Public Consultation
Submission Report –
First Non-Statutory
Public Consultation

BusConnects Dublin Core Bus Corridor Projects

Corridor 11 – Kimmage to City Centre

Emerging Preferred Route – Public Consultation Report 2018/2019

Section 1: KCR to Lower Kimmage Road / Sundrive Road [Kimmage Village].

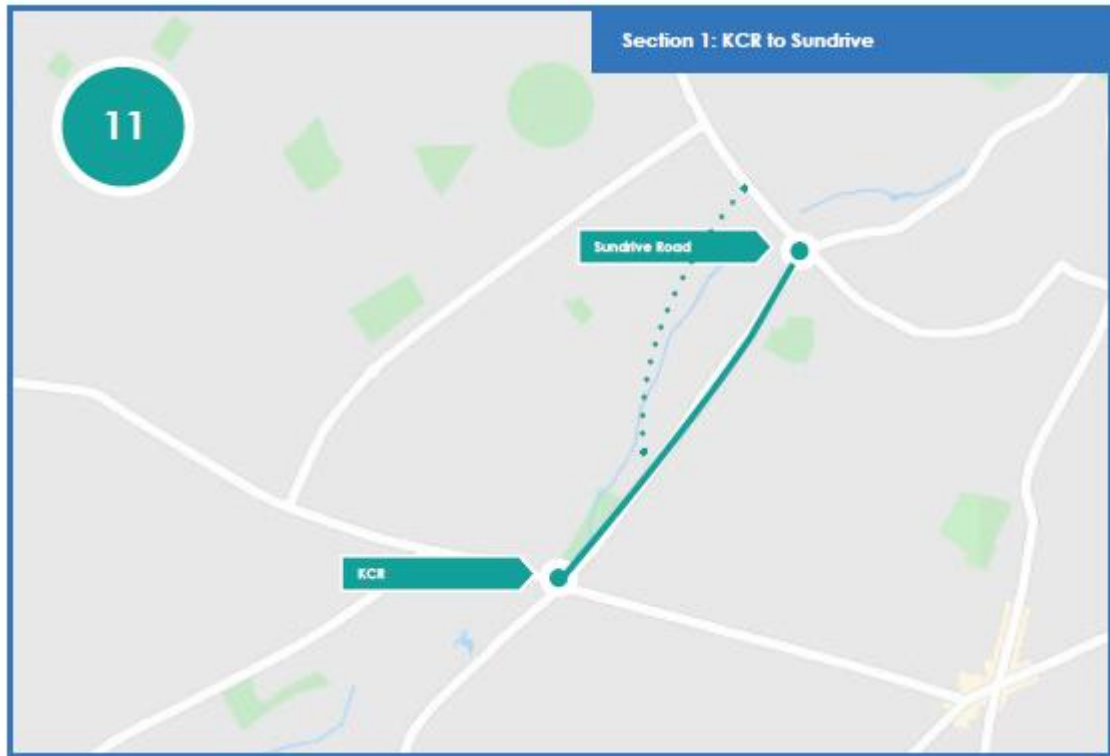
- Concerns over an increase in traffic along residential roads due to proposed bus gates; Concerns about fast cyclists on quiet roads;
- Concerns about the indirectness of the cycling route proposed;
- Concerns over reduced accessibility by car to their homes due to proposed traffic restrictions;
- Concerns over proposed widening of Lower Kimmage Road south of Sundrive Cross over a length of 0.5km, with land acquisition from approximately 40 properties to enable provision of bus lanes in both directions;
- Concerns about impacts on property values;
- Objections to the loss of parking spaces;
- Safety concerns, including pedestrian safety concerns;
- Queries about bus services and the need for the scheme;
- Community severance impacts; and
- Environmental impacts.

Section 3: Harold's Cross Park to the Grand Canal

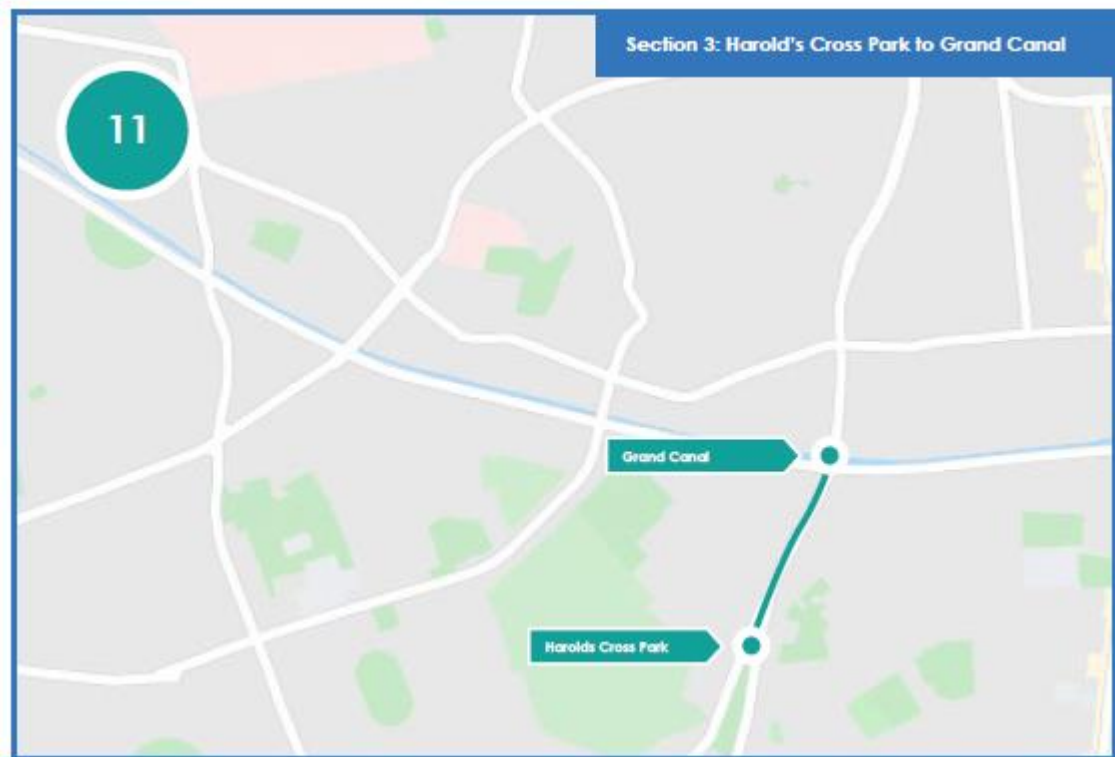
- Concerns over an increase in traffic along residential roads due to proposed bus gates; Concerns about fast cyclists on quiet roads;
- Objections to the proposed cycle route through the grounds of Our Lady's Hospice and along Greenmount Lane to Parnell Road at the Grand Canal.
- Objections to the loss of parking spaces;
- Concerns about impacts on property values;
- Concerns over reduced accessibility by car to their homes due to proposed traffic restrictions;
- General safety concerns, including pedestrian safety concerns;
- Queries about bus services and the need for the scheme;
- Flooding concerns at the River Poddle; and
- Environmental impacts.

Section 4: Inside Canal

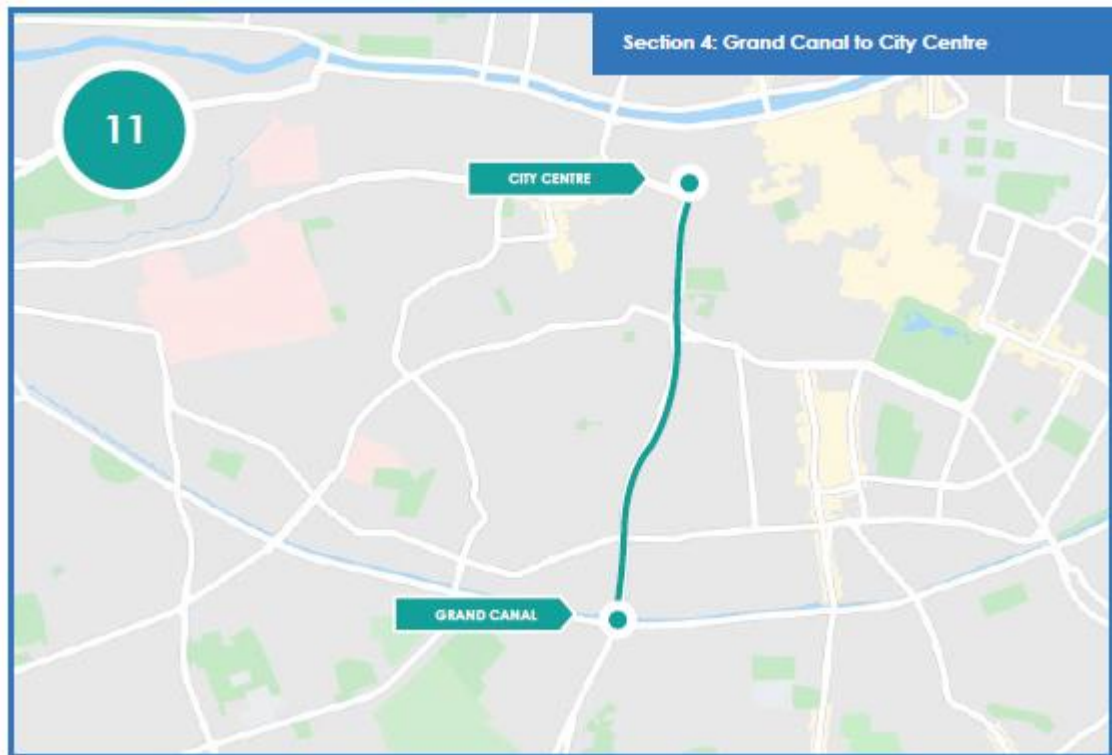
- Concerns about visual impacts of proposed bridges over the Grand Canal, including adjoining Robert Emmet Bridge on Clanbrassil Street;
- Concerns over reduced accessibility by car to their homes due to proposed traffic restrictions;
- Concerns about possible road widening;
- Objections to the loss of parking spaces;
- Queries about bus services and the need for the scheme;
- General safety concerns, including pedestrian safety concerns;
- Objections to the proposed closure of Heytesbury Street;
- Concerns about an increase in traffic on Pleasant Street; and
- Concerns relating to the need for cycling facilities on Clanbrassil Street.
